PROPOSAL, CONTRACT, BOND AND SPECIFICATIONS

BARTILLON SHELTER

CONTRACT NO. 9358

BIDDER QUESTIONS, CLARIFICATIONS, AND REQUESTS FOR SUBSTITUTIONS:

FS7

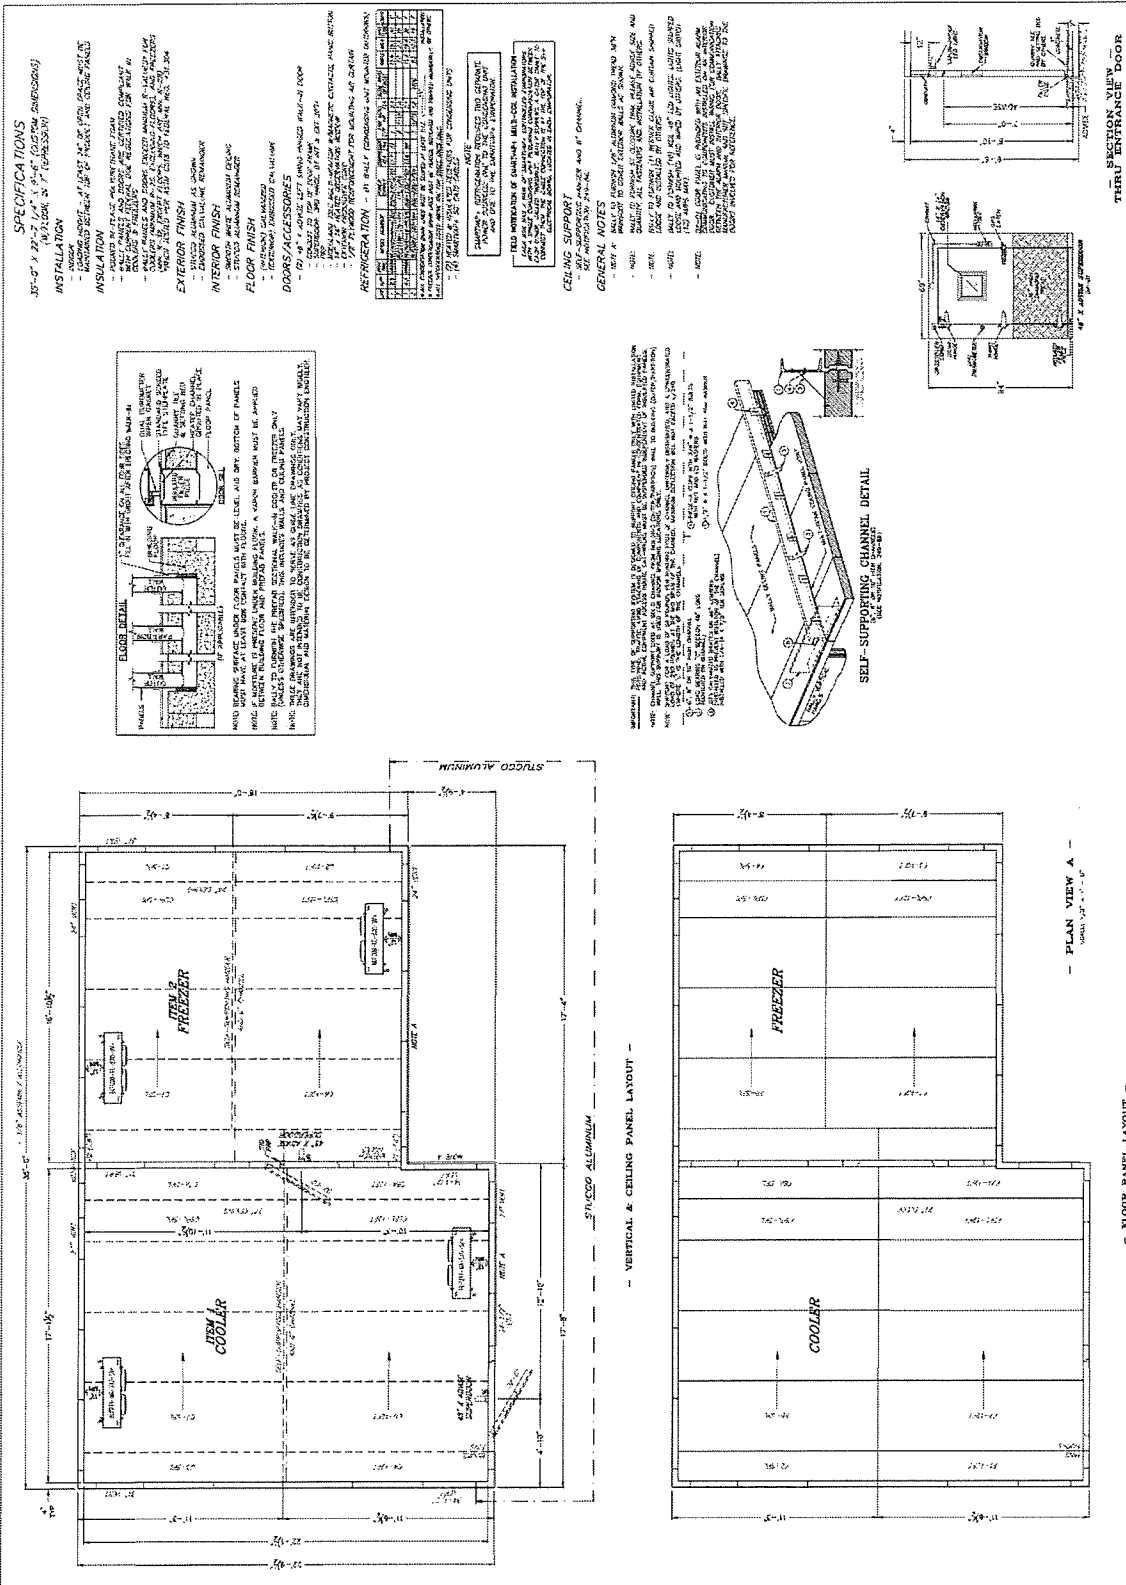
3. Please clarify the floor system and finish at the walk-in cooler/freezer. There is conflicting information between the drawings and specifications.
 - i. Drawing FS4 calls for an 8" recessed floor at the walk-in cooler area. Detail 4 on the same drawing indicates floor panels covered with grout and flooring by the GC.
Walk-in manufacturer will provide floor insulation at walk-in cooler and freezer. GC will provide concrete floor to match kitchen floor finish and elevation.

- ii. A section detail on drawing FS7 calls out a 7" recess with 3" concrete and quarry tile.
Floor depression shall be 8". Finish flooring to match kitchen floor finish.

AS1.1

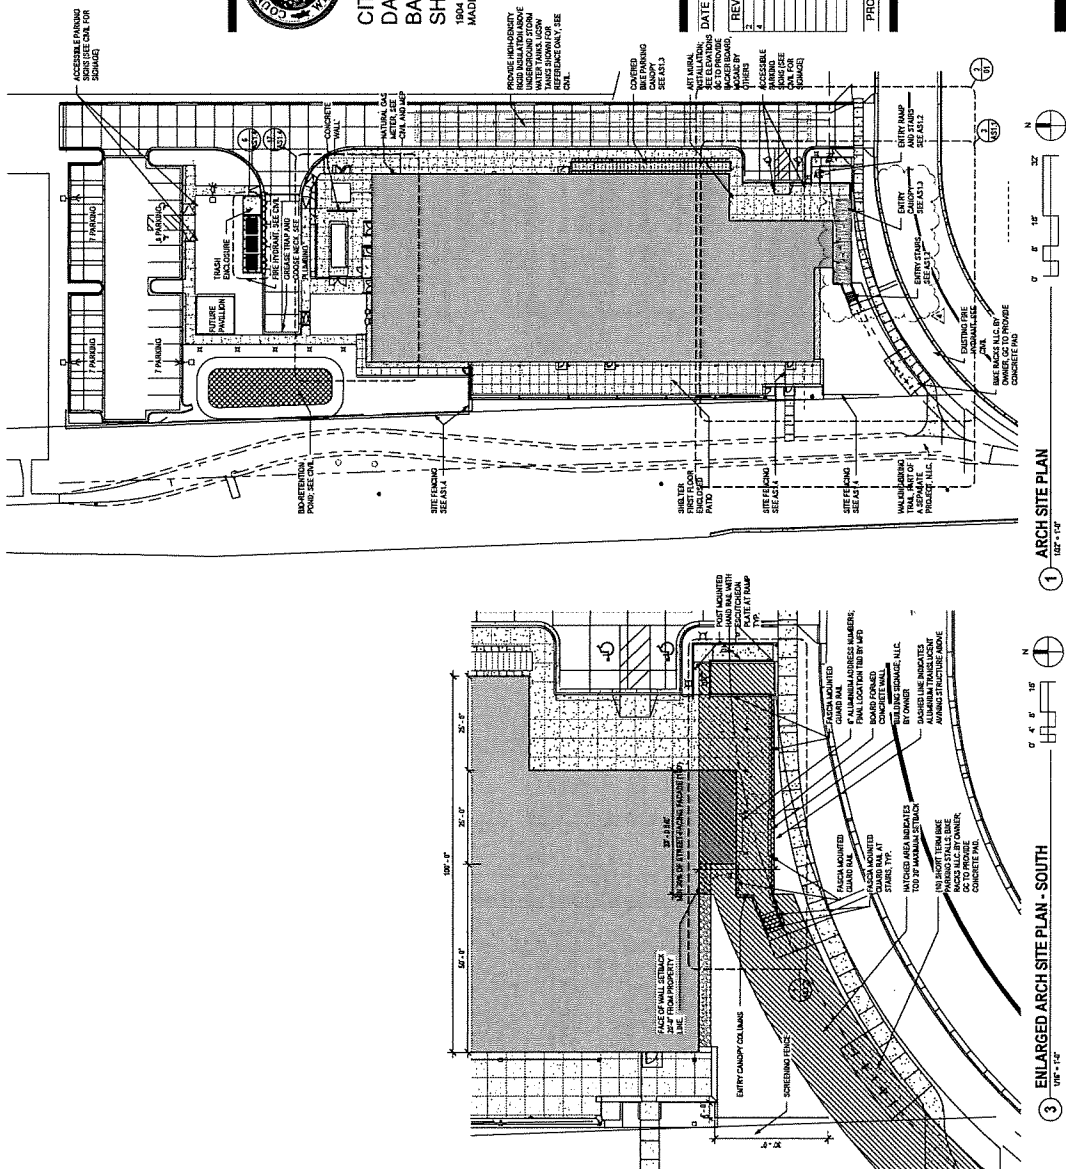
1. AS1.1 – ARCH SITE PLAN
 - i. Revise site entry to match Civil revisions
2. AS1.2 – ARCH SITE PLAN – ENTRY RAMP
 - i. Revise site entry to match Civil revisions

2. AS1.1 – ARCH SITE PLAN
 - i. Revise awning dimensions to match revisions made in Addendum 2.
3. S0.2 – STRUCTURAL NOTES
 - i. Add Pier P5 to Concrete Pier Schedule

S8.11

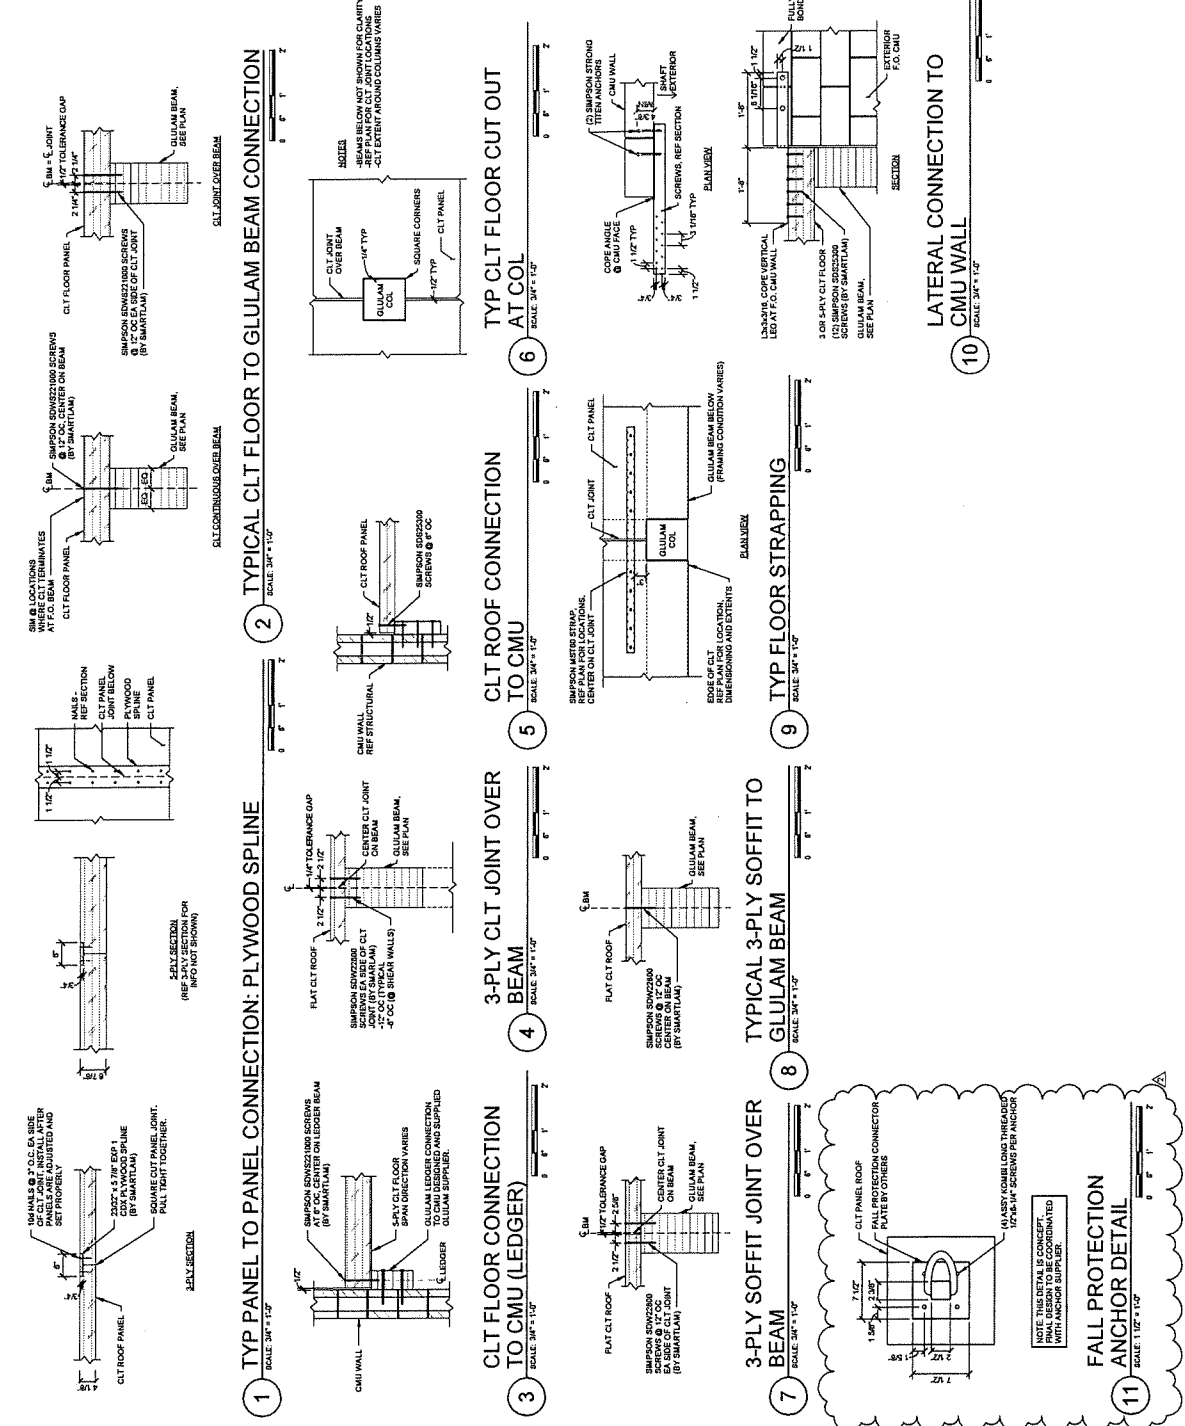
- i. Revise column sizes
7. S8.11 – STRUCTURAL DETAILS
 - i. Add fall protection anchor detail
8. S8.12 – STRUCTURAL DETAILS
 - i. Revisions to details and connections
